# ADA Curb Ramp New Construction Inspection Form (Parallel)

Nw 314th ave

24952.54

Nw. Commercial st.

PARALLEL RAMP (PL)

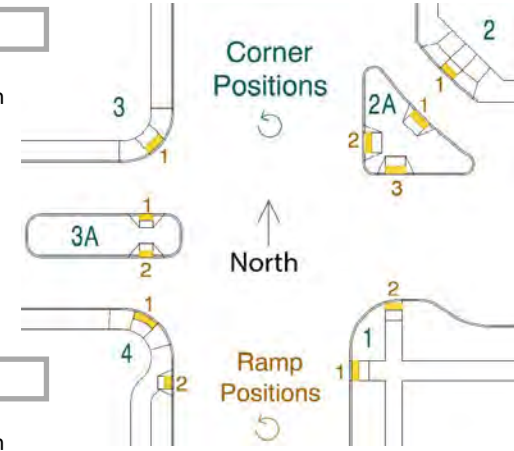
15.2  $\leq$  2.0% ☐  $>$  2.0% ☒

6.9  $\leq$  2.0% ☐  $>$  2.0% ☒

1.0  $\leq$  1/4" ☐  $>$  1/4" ☒

5.1  $\leq$  |5.0%| ☐  $>$  |5.0%| ☒

3.5  $\geq$  4.0' ☐  $<$  4.0' ☒

No dome, no RR2, no RR3
